Interactive comment on “Rain concentration and sheltering effect of solar panels on cultivated plots” by Yassin Elamri et al.

Received and published: 17 October 2017

Fig. 1. rain depths (mm) collected in the two lines of collectors (“Ligne 1, Ligne 2)

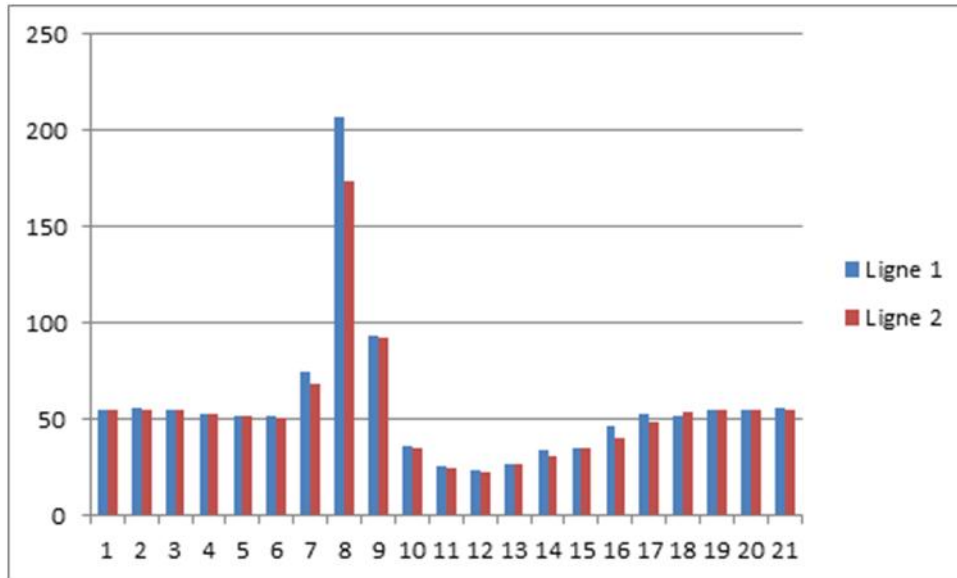
R1: Line 129 and Fig. 1: For a better evaluation of distribution uniformity under the solar panels it would be better to use a grid of collectors or replicate the series of 21 collectors more times along the PV row. The results here reported should be consid-

ered partial. See also the comment below on the use of coefficient Cv.

We used a second series of rain collectors indeed for event #12. The results we very close to each others in the two series of collectors (see below).

See as attached document: Figure 1 : rain depths (mm) collected in the two lines of collectors ("Ligne 1, Ligne 2) See as attached document: Figure 2 : correlation between rain depths collected in the two lines

Due to the time necessary to collect all the samples, we could not increase the sampling, so we agree to indicate them as partial. The results could be used nonetheless to check the validity of the model AVrain, where no calibration was necessary to fit on the data (for any of the 12 rain events described in the manuscript).

Fig. 3. Correlation between DU and Cv

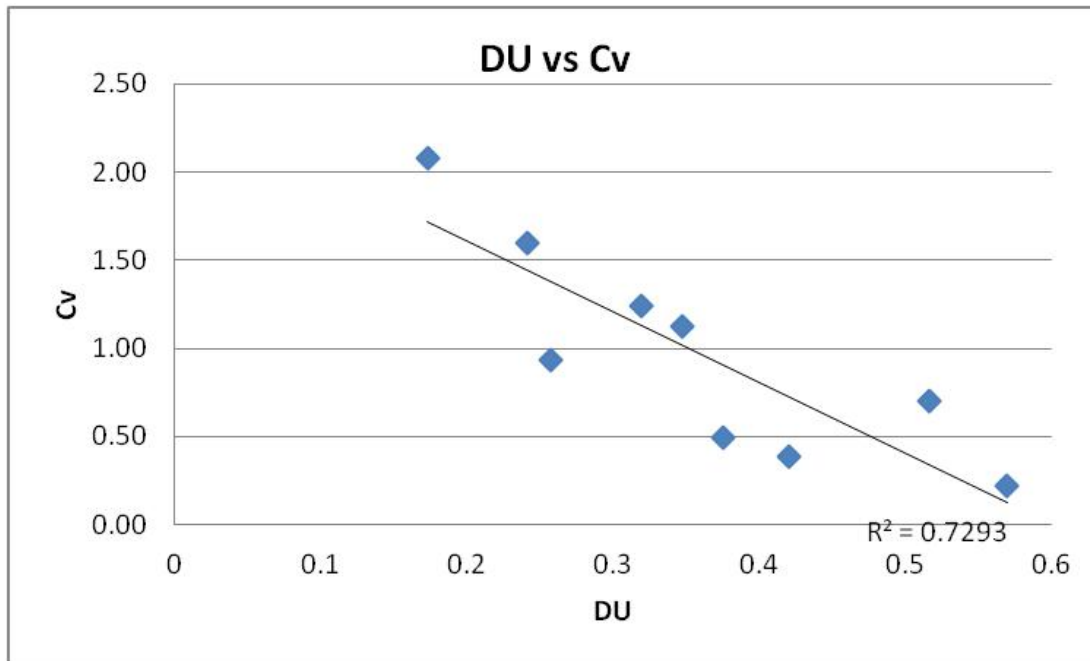
R1: Lines 259-268: I think that the coefficient of variation Cv here cited by the authors is the manufacturer's coefficient of variation or a measure of discharge of a random sample of emitters useful for microirrigation system design. It doesn't describe the uniformity of water distribution by the irrigation system. In this case it is more appropriate

the use of the low-quarter distribution uniformity DU also reported in Burt et al. (1997). But in this case it would be better to have data collected in a grid of collectors. The authors are invited to better explain and justify their choice.

R1: Table 1: As regards the Cv see also the comment above. The values here reported are not supported by a proper data analysis.

There are indeed different manners to estimate the uniformity of application. Notably Christiansen's uniformity coefficient defined as: $UC = 100\% \cdot (1 - (\text{average deviation from the averaged depth}) / (\text{overall average depth of application}))$ is a widely used method of uniformity evaluation for sprinkler systems (Burt et al. 1997). Our coefficient of variation is merely related to UC: $Cv = 1 - UC$. The advantage of using UC (or Cv, which is equivalent) is that the uniformity of rain application due to panels can be compared to the one caused by usual spray irrigation systems. It is however interesting to use other uniformity indicators as suggested by the reviewer, such as DU. DU will use the average of the lower quartile, so the rain depths obtained under the solar panels. Obviously, DU and UC (or Cv) are correlated, as also reported in Burt et al. (1997). This can be observed in the attached figure (figure 3). Therefore, both methods will give similar conclusions. The final version will include a remark about that.

We agree that these values are not reported in a unique document. The article of Burt et al. (1997) indicates the value of 80% for fair uniformity. It also indicates the linear behavior between DU and CV (equations 14, 15): $DU \approx 1 - K \cdot Cv$ with $K \approx 1$. Therefore we selected the threshold of $Cv = 0.2$ for fair distribution. This is supported by other studies using Christiansen coefficient: "Catch can measurements are used to determine the uniformity of a sprinkler irrigation system. Christiansen (1942) developed a numerical index representing the system uniformity of overlapping sprinklers. This uniformity coefficient (UC) is a percentage on a scale of 0 to 100 (absolute uniformity). A uniformity coefficient of 80 is considered by many to be the minimum acceptable performance. Higher uniformity coefficients are usually needed with intensively maintained ornamentals. Catch can measurements are also used to illustrate water distribution or
